Access Compliance Report

Public Rights-of-Way

(Pedestrian Signals)

Intersection ID: N/A	Main Street:	Cross Street: N/A	Location: N/A
ADA ID: 2597DD199A4C	Signal Type: Two Push Buttons-Non APS	Overall Compliance: No	Severity Score: BTN 1:N/A BTN 2: N/A No BTN: N/A
Codes/Mitigation Info/Possible Solution		Field Measurements/Component Compliance

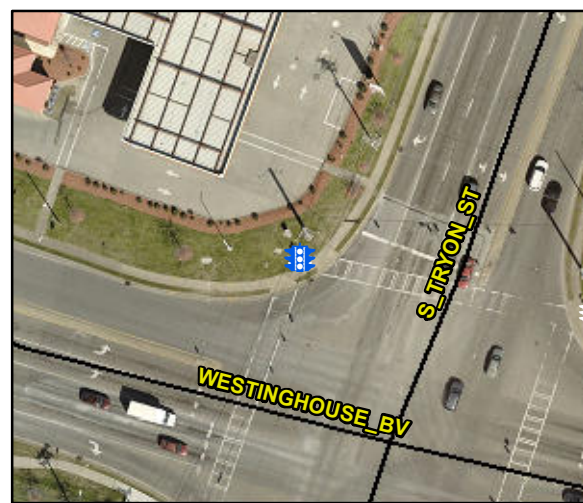
Surveyor Notes: TEXT HT 3/8

PROW/ADA: R410.6, TMUTCD 4e.08, R404.2, R404.3, R406.2, R406.3, R404.7.2

Possible Solutions: Replace Signal Push Button With APS Button on New Post. Remove & Replace Sign.
